Pedestrian and Cycling Improvements to Ferry Lane – Briefing Note

This note provides further information in response to comments regarding proposals for pedestrian and cycle network improvements on Ferry Lane, to provide improved access to Tottenham Hale station from the east following its upgrade. These proposals are the subject of a planning application to London Borough of Haringey (LB Haringey) – Planning Reference: HGY/2023/3078.

Figure 1 Cross-section drawing of the proposed link bridge between Hale Village and the existing station structure viewed from the north.

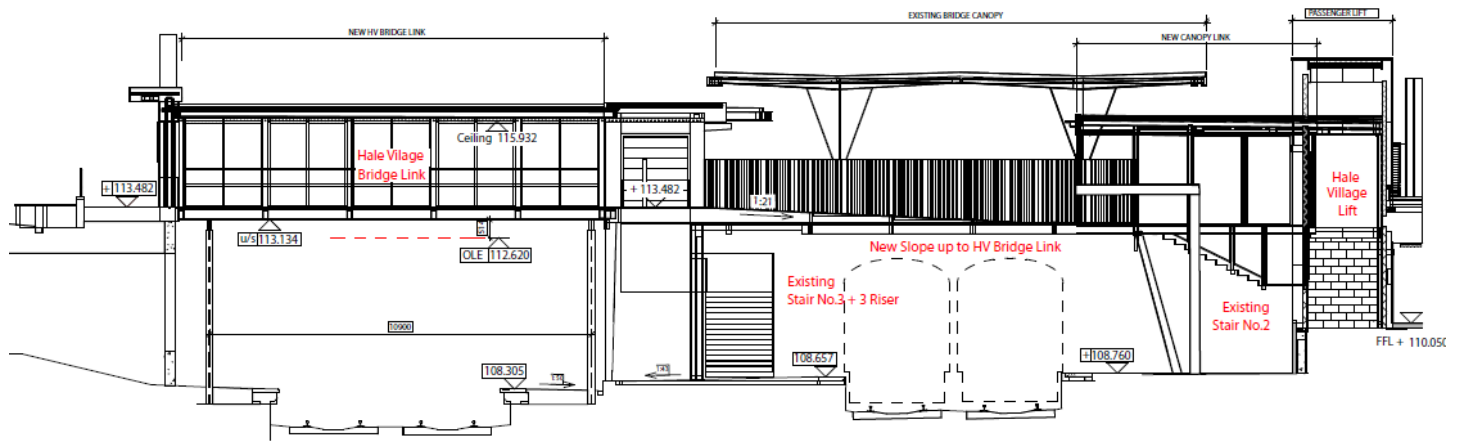
Some respondents highlighted that the decision to approve the original planning application was made on the condition that the new pedestrian footbridge was delivered. That TfL should therefore be held to this requirement to deliver the bridge.

The link bridge is no longer deliverable as the costs have become much higher than they were originally forecasted, and additional operational costs would be generated in perpetuity to staff a required gate line. The cost of the bridge dramatically increased from an original estimated cost of £2-3m to circa £9m in 2019 (now expected to be above £10m). Whilst TfL were able to find additional funding to cover half of the revised costs for the bridge, Network Rail and the Department for Transport made it clear that no further funding was available to cover the remaining costs.

With the original bridge now required for station operation, a redesign was required to provide 'unpaid' access through the station. Network Rail/Greater Anglia required inclusion of a gate line at the Hale Village end of the bridge for revenue protection which would also involve ongoing additional maintenance cost in perpetuity and require staff supervision. The review of options also coincided with changes in national regulations relating to the proximity of structures to the overhead cables for trains, resulting in a requirement for the bridge extension to be elevated and not the simpler 'parallel' extension originally proposed. Figure 1 (below) is a drawing of the link bridge that includes the elevation and ramping down to the existing bridge.

Figure 2- Revised Cross-Section Showing changes in lane widths.

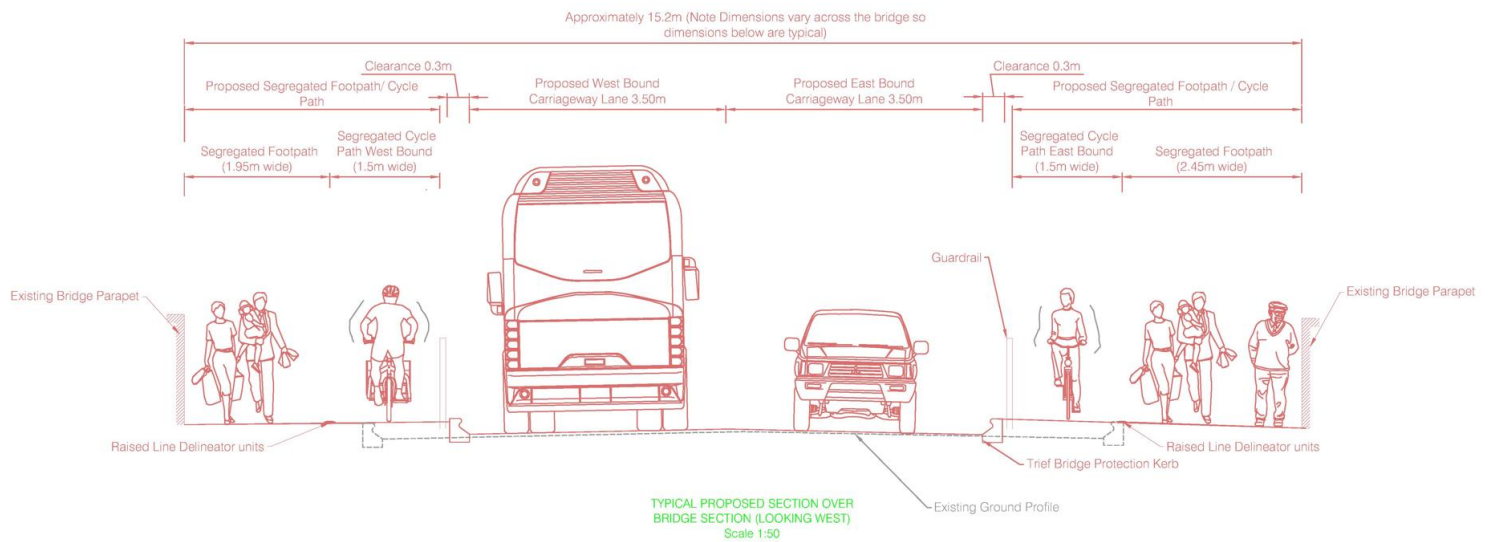
Many respondents expressed concerns over the present levels of pedestrian congestion experienced going over Ferry Lane bridge, the importance of accessing the station and ensuring access to leisure and nature, such as the Walthamstow Wetlands further to the east. They suggested that the proposed arrangements would not be able to accommodate current pedestrian numbers, so would struggle to accommodate further growth following the build-out of consented developments to the east of Tottenham Hale. One respondent queried how representative the pedestrian survey figures are that were used to inform the design.

Some highlighted that the scheme, as submitted, results in a reduction of space for pedestrians on the south side and are not supportive of this change.

To provide assurance that our proposals can accommodate for the present and future levels of pedestrian congestion, we have conducted a Pedestrian Comfort Level Analysis (PCLA). This tool and associated guidance aim to ensure that footway designs are appropriate to the volume and type of users of the environment. Pedestrian Comfort Level (PCL) is assessed on a scale of A (best) to F (worst), with the recommended PCL for most areas being a B+. At present the pedestrian comfort of both footways over the bridge section is poor, with ratings of F on the north side and for the majority of the footway an F rating on the south side.

Our analysis demonstrates that it is possible to achieve scores equivalent a B+ or higher on both footways, following some further tweaking to the design. Including changes in the placement of the metal barriers by adding width back to the southern footway, which some consultees have requested. This will enable both footways to accommodate the predicted footfall, based on our pedestrian flow surveys. Figure 2 below shows the revised lane widths that would deliver pedestrian comfort levels equivalent of B+

Figure 4 Diagram demonstrating the minimum clear widths required for different pedestrians (from London Cycling Design Standards guidance)

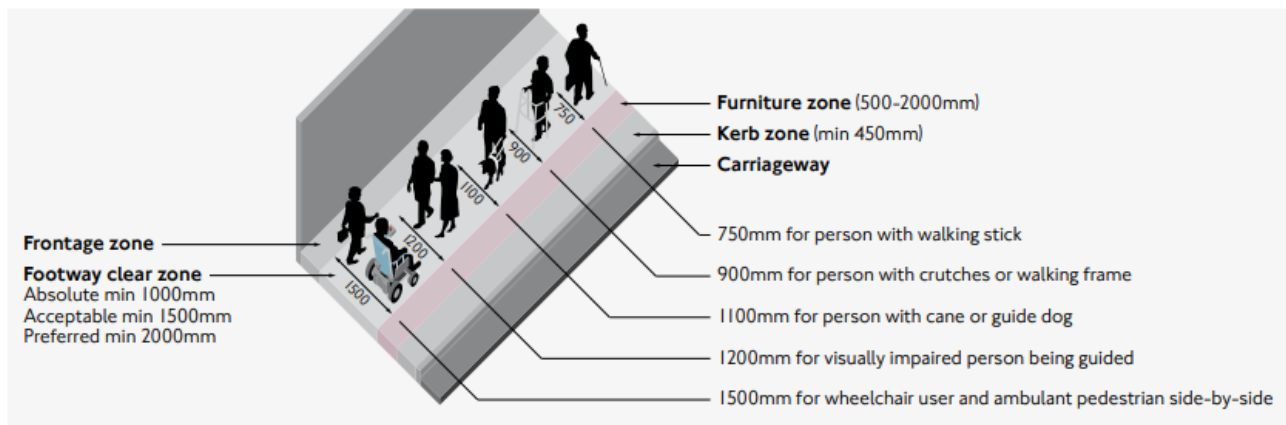
Some respondents have stated that the existing footways are not suitable for those with wheelchairs, or pushchairs, due to the levels of crowding experienced. This is likely not helped by the fact that the current Pedestrian Comfort levels are substandard. However, following some further tweaks to the distribution of space across footways (see response in 3.2). The scheme now delivers clear widths (i.e., paths that are unobstructed by signs, lamps, furniture) that will better accommodate for such users. Guidance states that a wheelchair user, accompanied by an ambulant pedestrian require a clear width of 1.5m (see figure 4 below) and this scheme delivers that. As the detailed design develops, engagement will be undertaken with specialist groups. Details of surface treatments and tactile paving will continue during this process.
